Westinghouse Electric Corporation **Energy Systems**

AW-97-1154

August 19, 1997

### APPLICATION FOR WITHHOLDING PROPRIETARY INFORMATION FROM PUBLIC DISCLOSURE

Figure 440.GC4-1

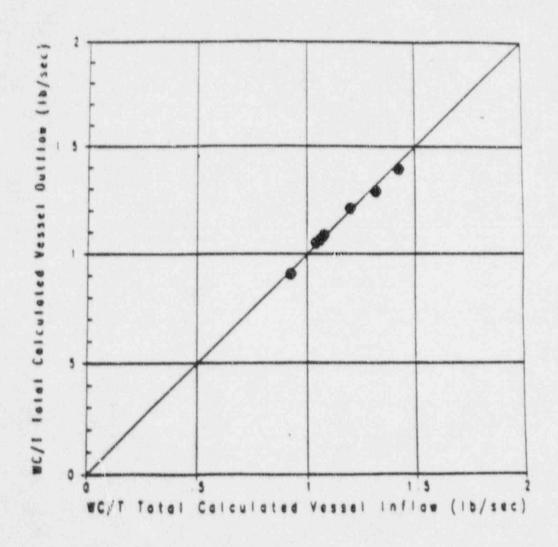
The mass ratio comparisons shown in Figure 6-8 appear to be contradictory. The figure shows that the ratio of flow out to flow in is greater than unity for the tests (indicating that vessel levels should be decreasing) and less than unity for the calculations (indicating that vessel levels should be increasing). Thus, the trends of the calculation appear to be wrong. The text should justify why these results are adequate.

The text will be updated to reflect a re-evaluation of the predicted ratios which were presented at the ACRS meeting and which pieced that WC/T inflow and outflow are equal. Figure 440.GC4-1. The deviations in the measured ratios results primarily from the uncertainty in the vessel inflow and outflow test measurements. This is a primarily the negative break flow rates become large, such as in Test SB01, since the flow meters were not calibrated for reverse flow at OSU. This effect is discussed in detail in RAI 440.589.

Figure 440.GC4-1

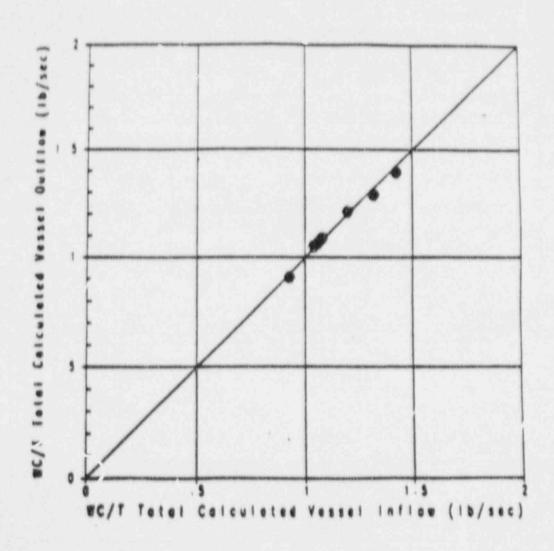
The mass ratio comparisons shown in Figure 6-8 appear to be contradictory. The figure shows that the ratio of flow out to flow in is greater than unity for the tests (indicating that vessel levels should be decreasing) and less than unity for the calculations (indicating that vessel levels should be increasing). Thus, the trends of the calculation appear to be wrong. The text should justify why these results are adequate.

The text will be updated to reflect a re-evaluation of the predicted ratios which were presented at the ACRS meeting and which showed that WC/T inflow and outflow are equal, Figure 440.GC4-1. The deviations in the measured ratios results primarily from the uncertainty in the vessel inflow and outflow test measurements. This is significant when the negative break flow rates become large, such as in Test SB01, since the flow maters were not calibrated for reverse flow at OSU. This effect is discussed in detail in RAI 440.589

Figure 440.339-4 - SPES-2 PRHR Model (6 Node PRHR With Influence Zone)

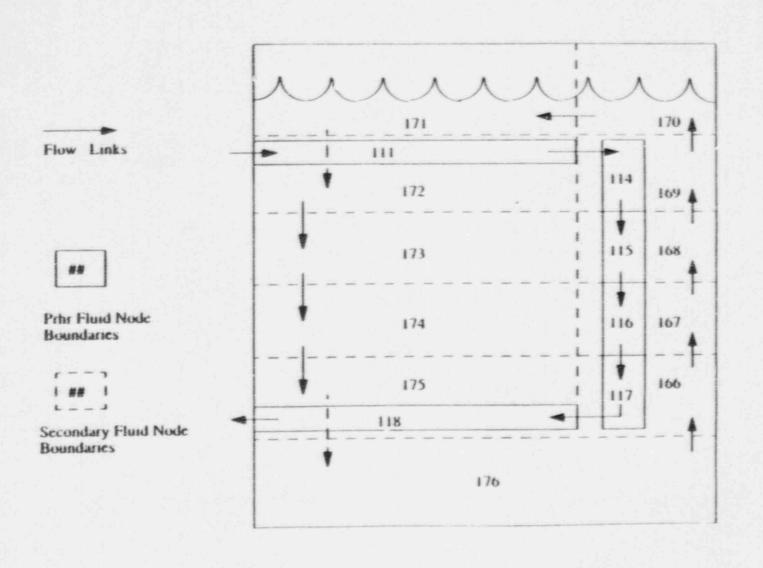
The purpose of this portion of the study is to determine the effect of alternate noding of the primary side of the PRHR. The IRWST is modeled as two nodes as in the Preliminary Validation Report. Three different noding schemes are studied as shown in Figures 440.339-1 through 440.339-3. The first scheme is a three node PRHR model (Figure 440.339-1). This model provides a basis for the rest of the study. The second model (Figure 440.339-2) is a four node PRHR model, with two horizontal nodes to model the top horizontal section of the PRHR piping. The third model (Figure 440.339-3) is a five node PRHR model, with three horizontal nodes to model the top horizontal section of the PRHR piping. Two boundary nodes, one at the entrance and the other at the exit of the PRHR were modeled at subcooled fluid conditions, with the inlet flow varying between 1.0 and 0.175 lbm/sec (with a flow velocity varying between 8.4 ft/sec and 1.7 ft/sec). Based on Reference 440.339-3, which indicates that a large fraction of the total PRHR heat transfer occurs in the initial horizontal section of the PRHR rubes, it was believed that renodalization of the top horizontal section of the PRHR rube would result in closer agreement with the test data. However, the results of this study (discussed later) show that the horizontal nodalization has negligible effect on the calculated PRHR outlet temperatures. This led to the renodalization of the vertical section of the PRHR rubes, which is discussed in Part 2 below.

PRHR rube. The first model (Figure 440.339-4) is a four node model and the second model (Figure 440.339-5) is a 16 node model. The secondary side of the PRHR is renodalized (using 11 nodes) which includes an influence zone described below.

Figure 8-2. Downcomer Void Fraction: Channels 53, 42, and 31

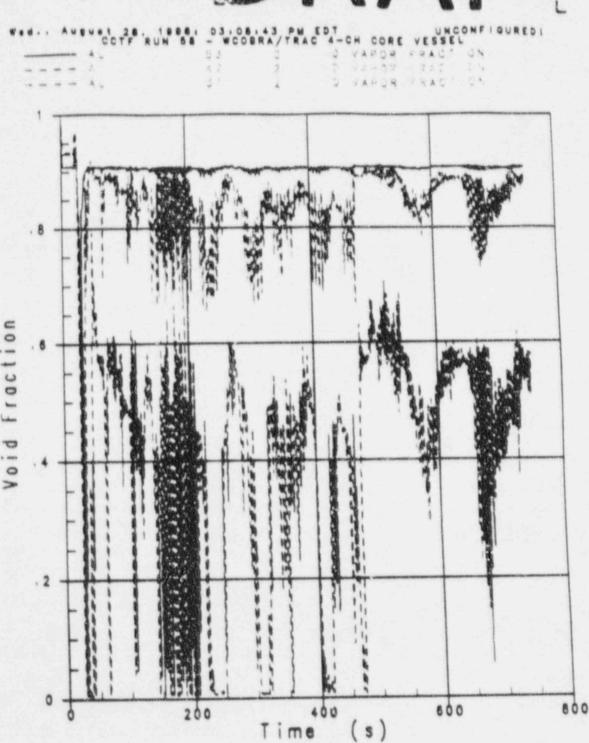
Westinghouse did not clarify the reasons for differences between the code results and the data for the core and downcomer differential pressure differences or the steam flows in the cold legs or the liquid flows in the hot and cold legs. (Discussion Item 60, May 17, 1996, letter).

Figure 8-2 shows the predicted void fraction Channels 53, 42, and 31. Channels 53 and 42 remain at relatively high void fraction throughout the simulation. The void fraction in Channel 53 is fairly constant at  $\alpha=0.9$ , because of the constant injection rate of coolant from the DVI into that cell. The void fraction in Channel 31 is seen to oscillate, with  $\alpha<0.6$  except for a few brief periods.
